***Provisional Maturity Science Review
For NOAA-20 OMPS
Total Ozone EDR – V8TOz***

***Presented by Lawrence E. Flynn
Date:2018/10/02***

Notes from first review

Ozone v8TOz (Total Column)

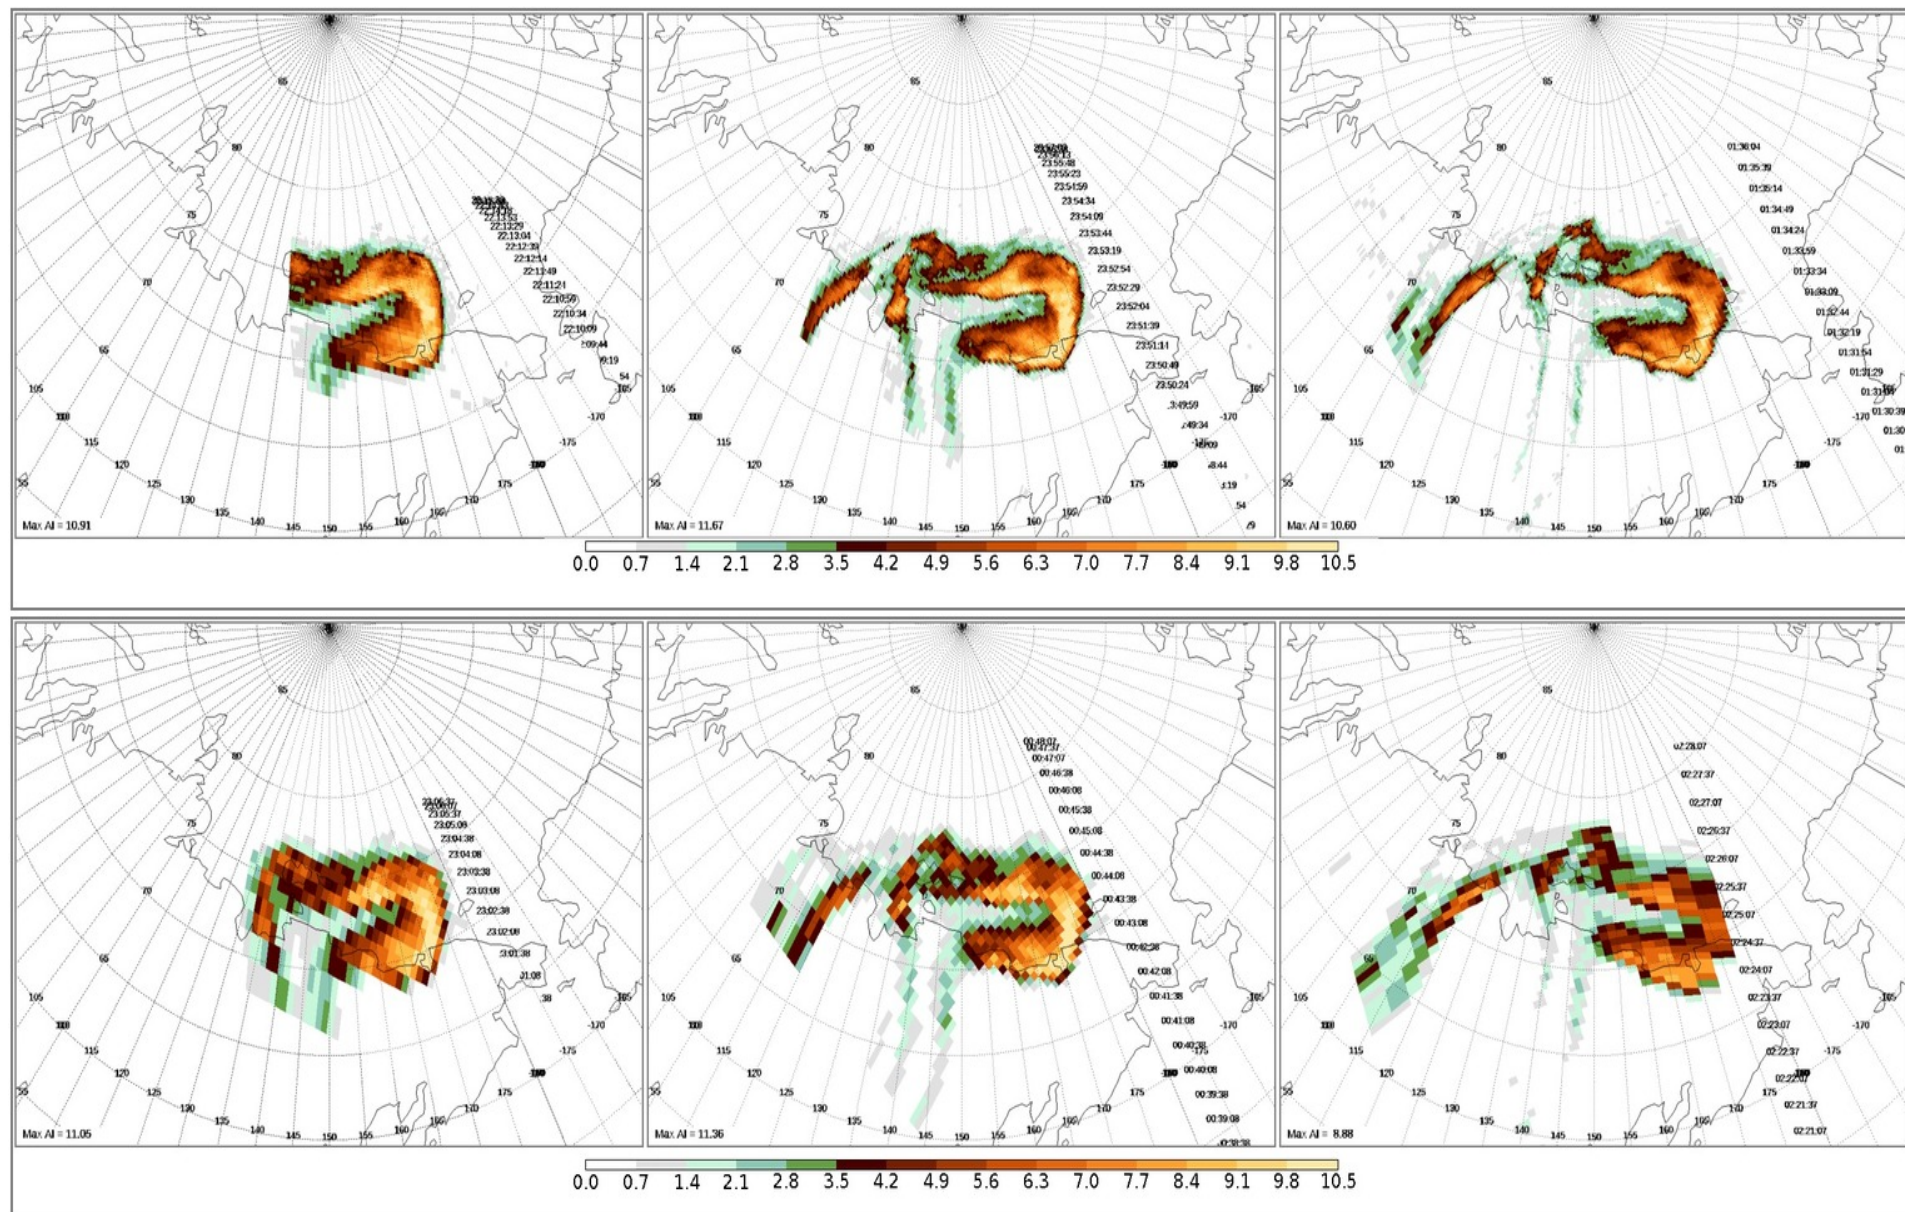
- • Slide 9 - for geographic coverage, recommend the 90% daily global earth is done per requirements for validated review. How does "SZA < 70°" translate to % earth covered?

LF Comment: SZA < 80° satisfies 90% coverage. SZA<70 Degrees is still over 80%.

LF Comment: The coverage for NOAA-20 is the same as for S-NPP.
